**Bastrop County Precinct 2 Road and Bridge Facility Construction**

**RFB 25BCP04J**

**ADDENDUM #2**

Addendum #2 provides clarification and answers from questions submitted by contractors and has an updated drawing and specification package as some aspects of the project have changed. Bastrop County is extending the due date for submissions until June 4, 2025, at 2:00PM. The new deadline for questions concerning the scope of work is May 27, 2025, at 5:00PM. Below is a list of documents that are included in Addendum #2:

SHEET  
**A400**

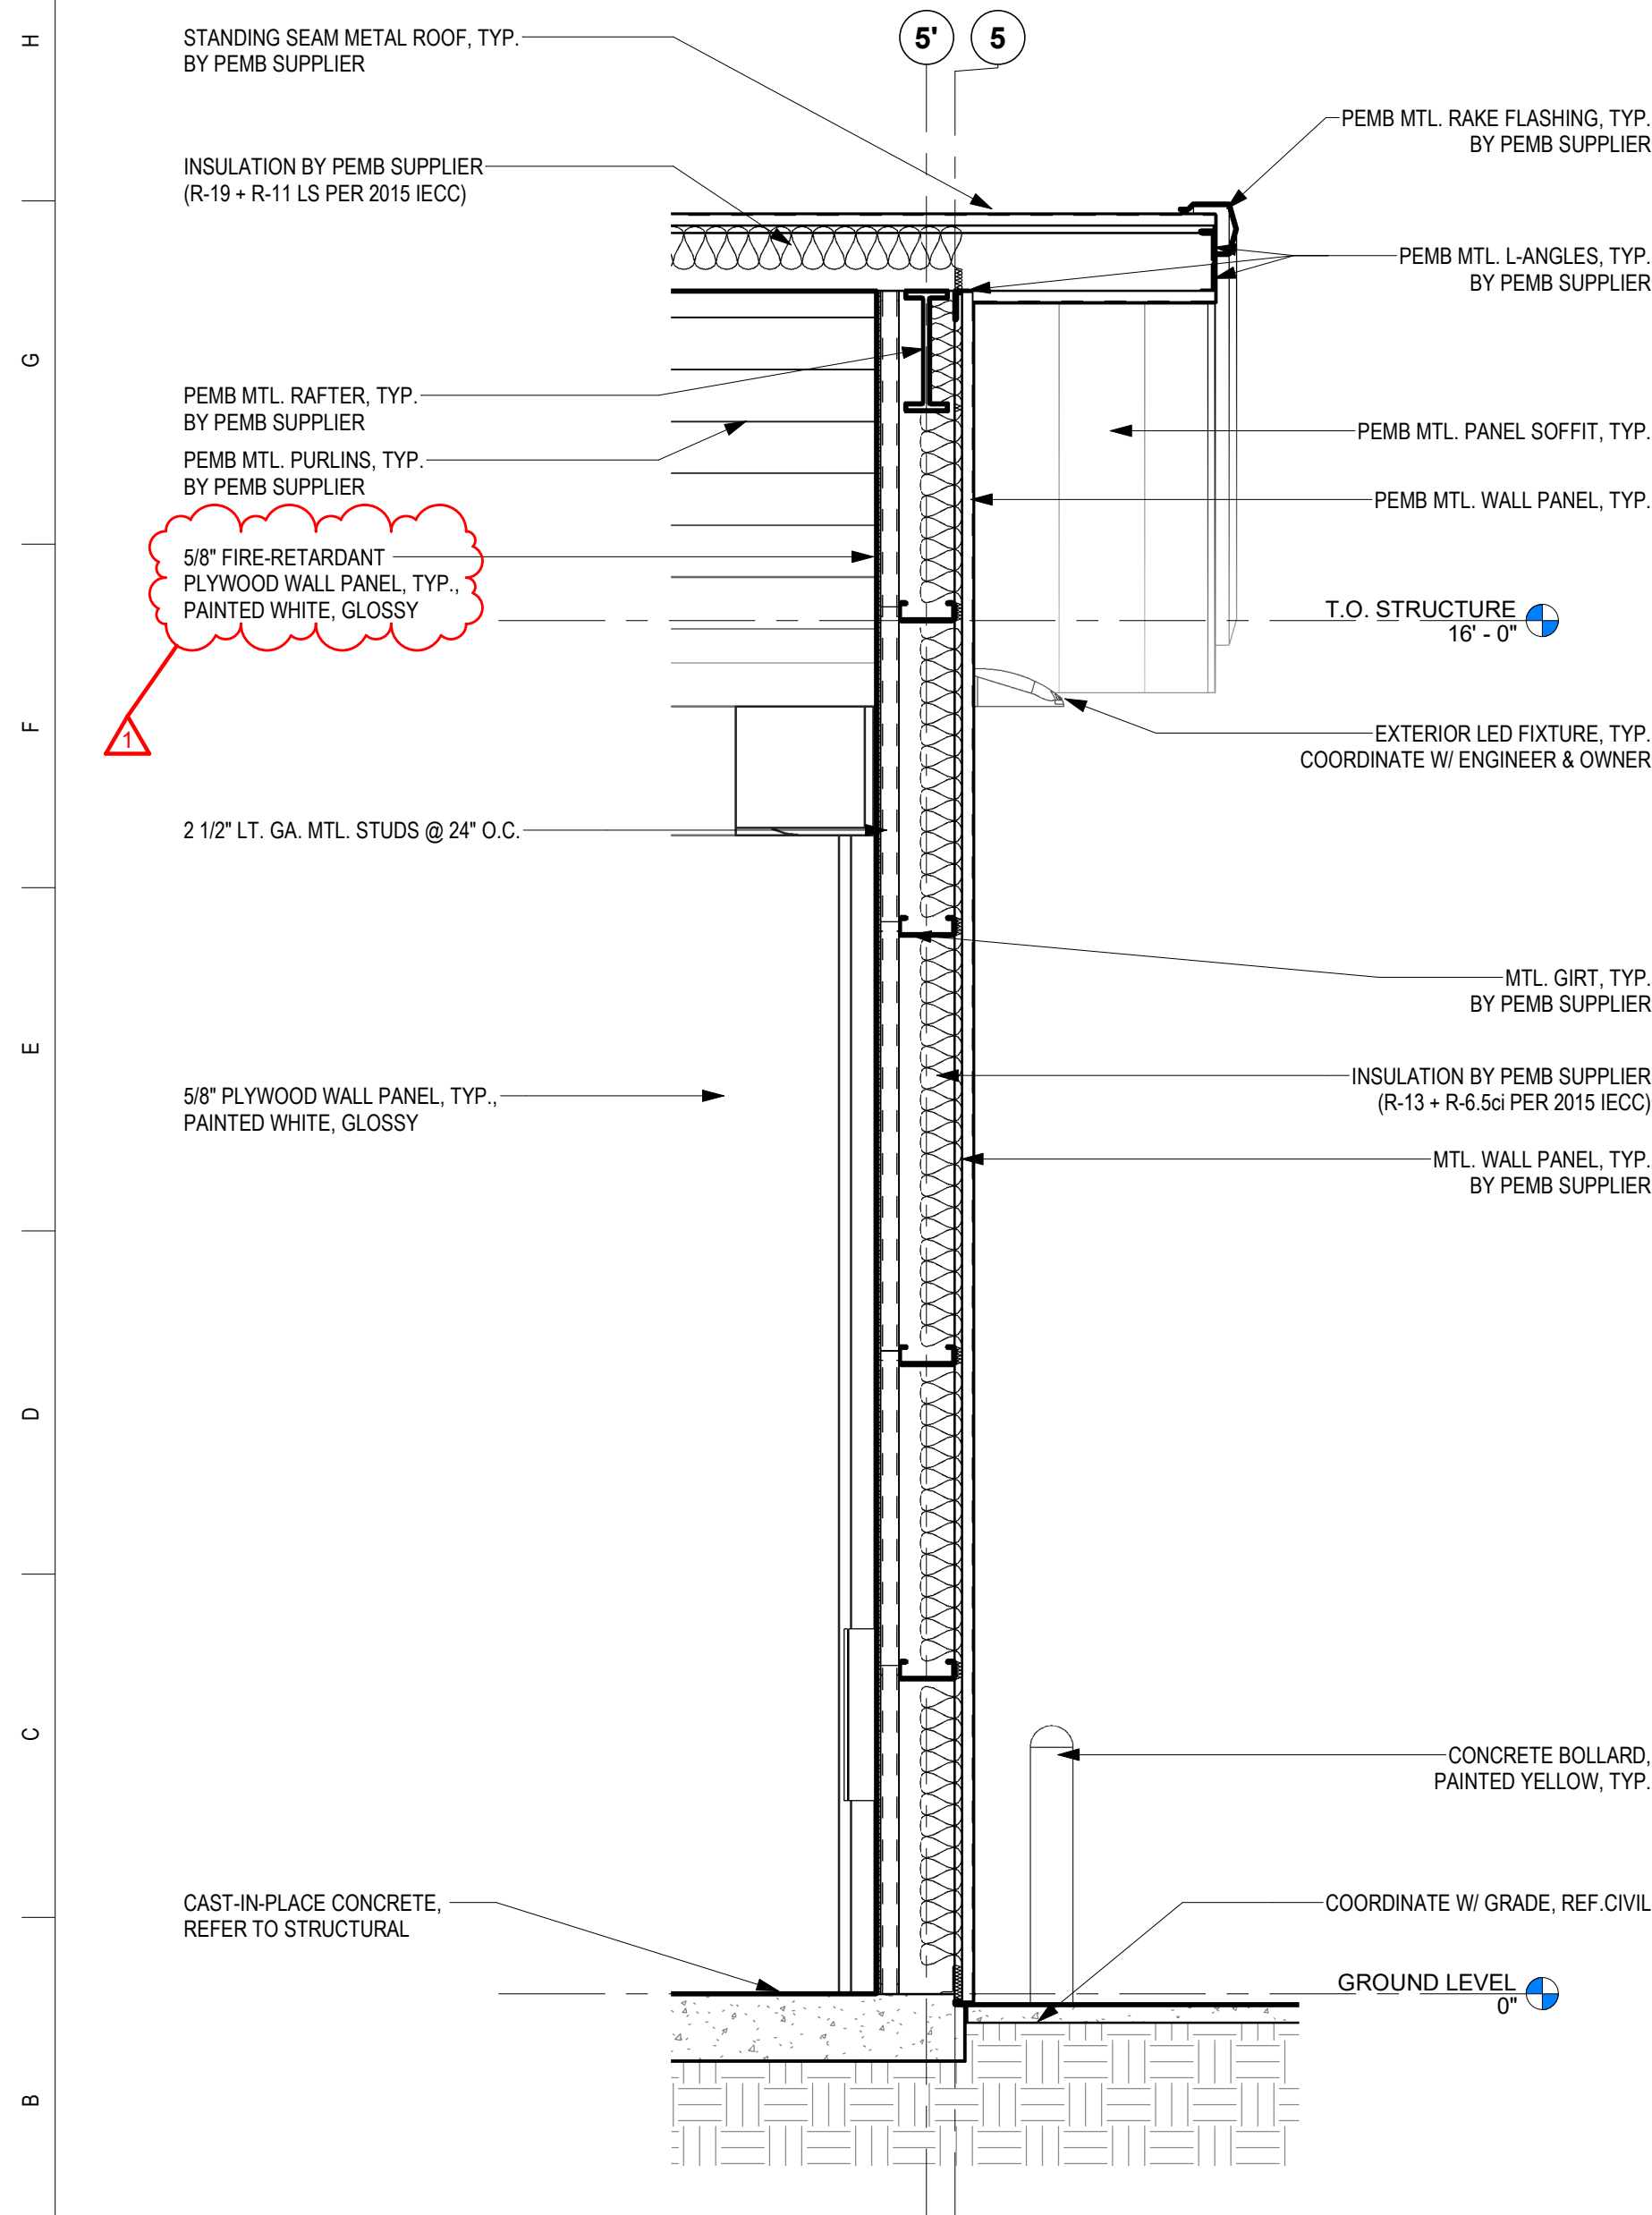
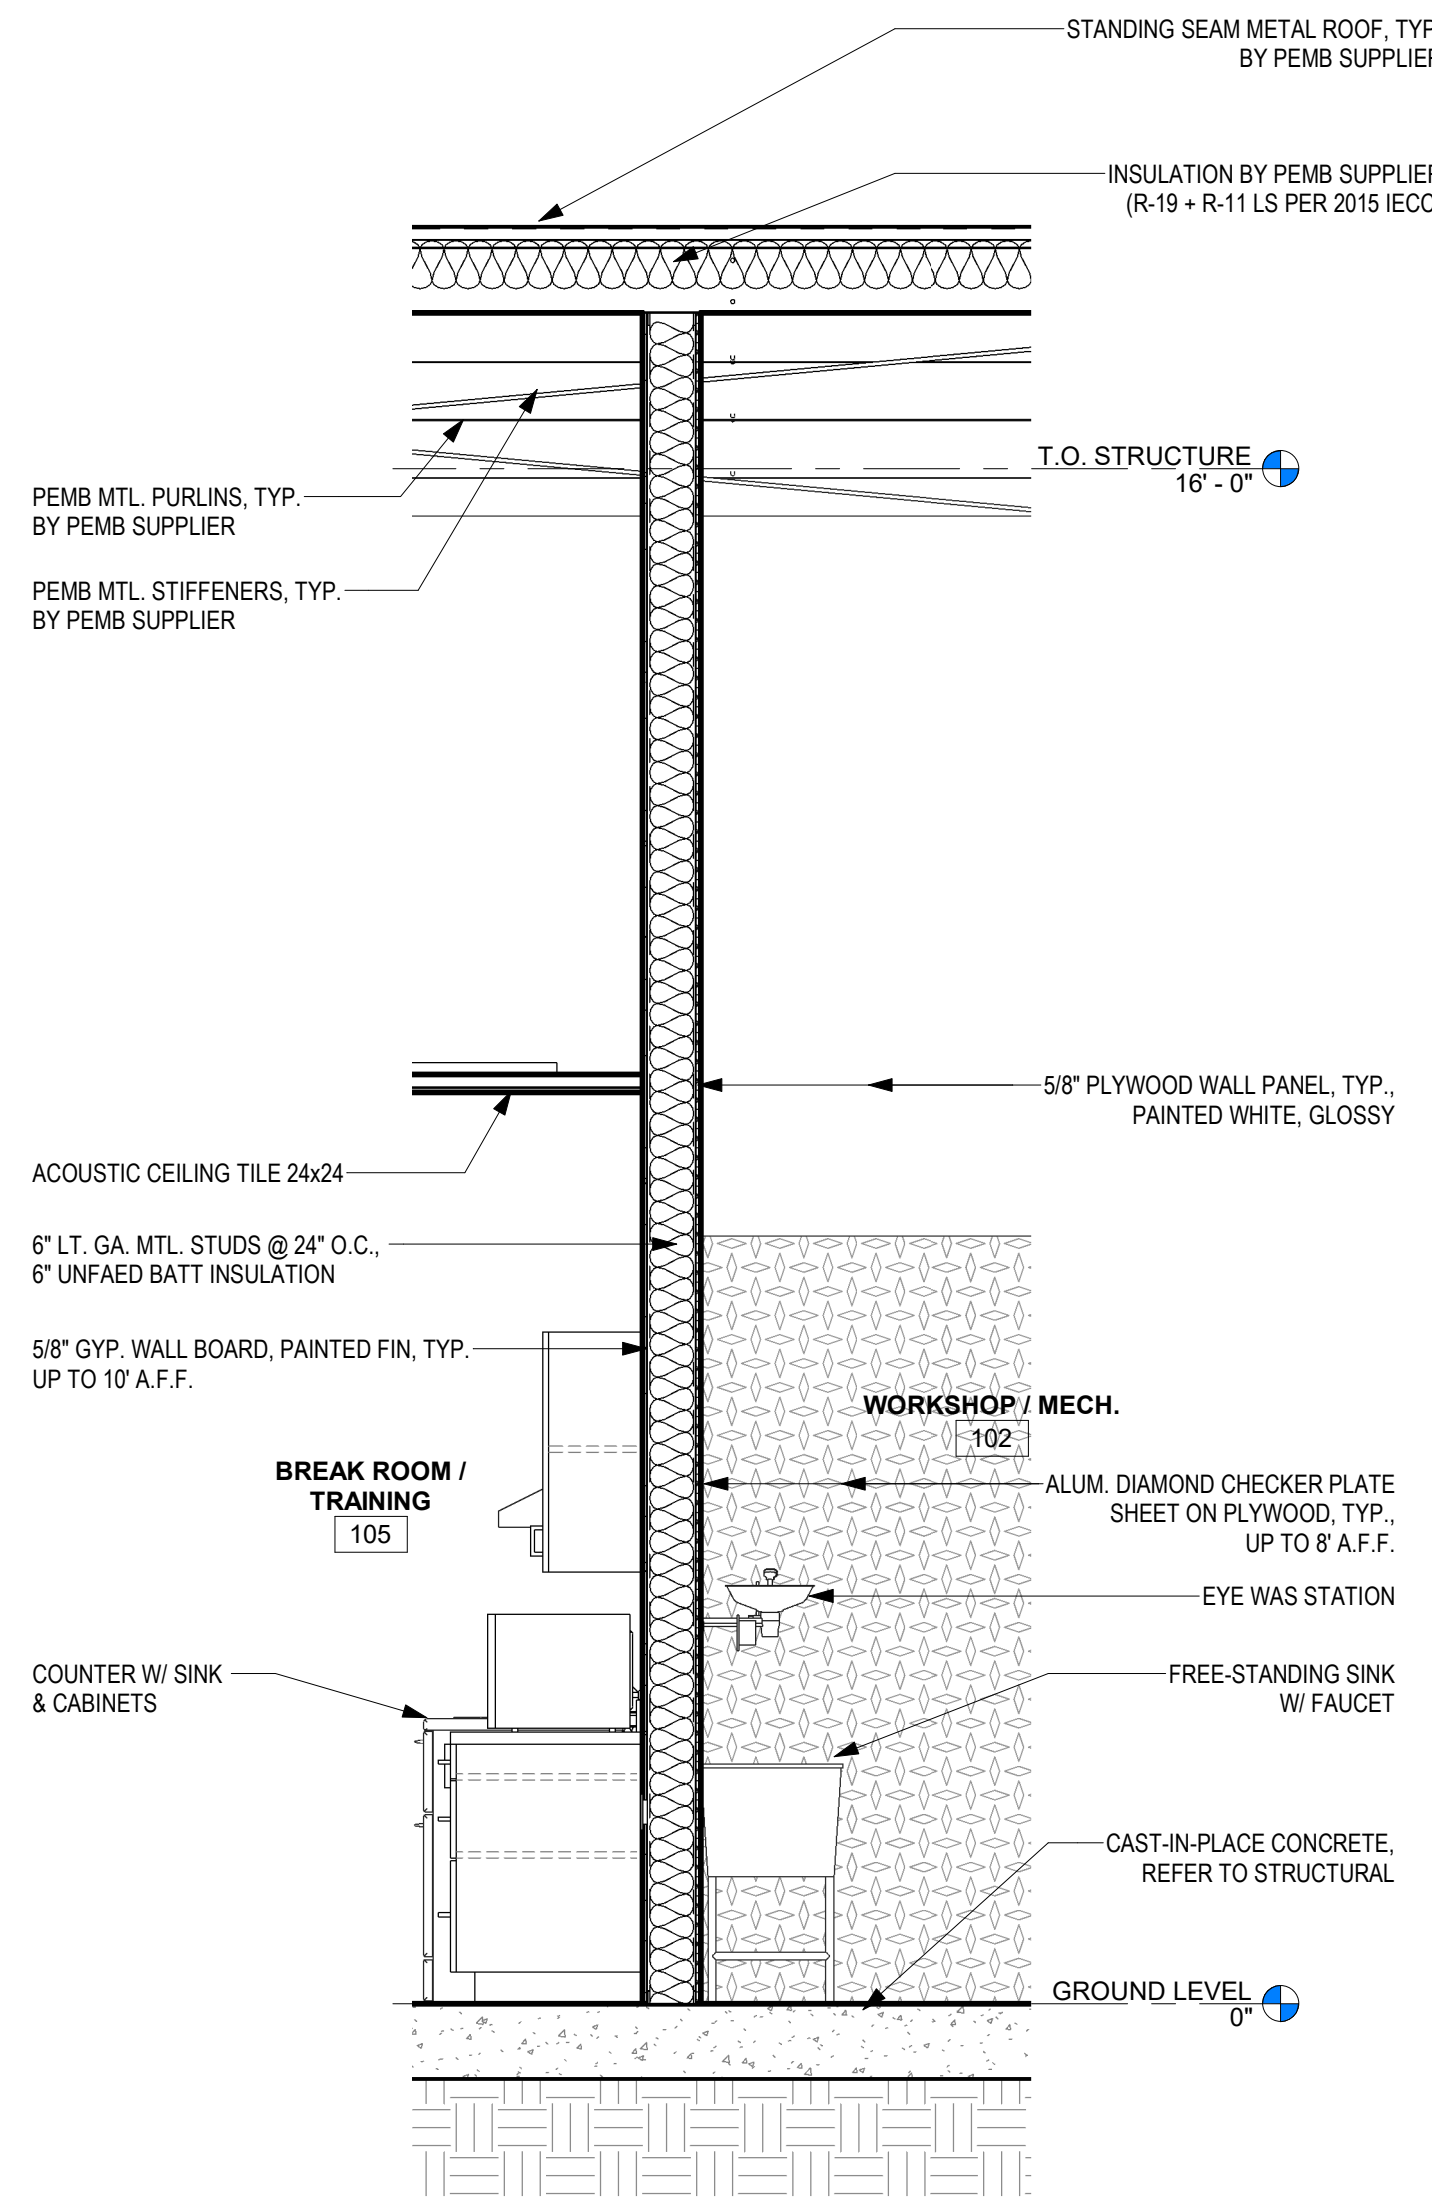
*4. Sheets A400, A401 - Details on these pages show 5/8 plywood as being installed on the walls. As this building is classified as a IIB building per the information provided on sheet A006. Provide documentation to show the use of 5/8 plywood exposed on the wall surfaces complies with Section 603.1*

CasaBella Architects Response: Refer to revised sheet A005, A400, 401, call out for fire-retardant plywood at exterior walls.
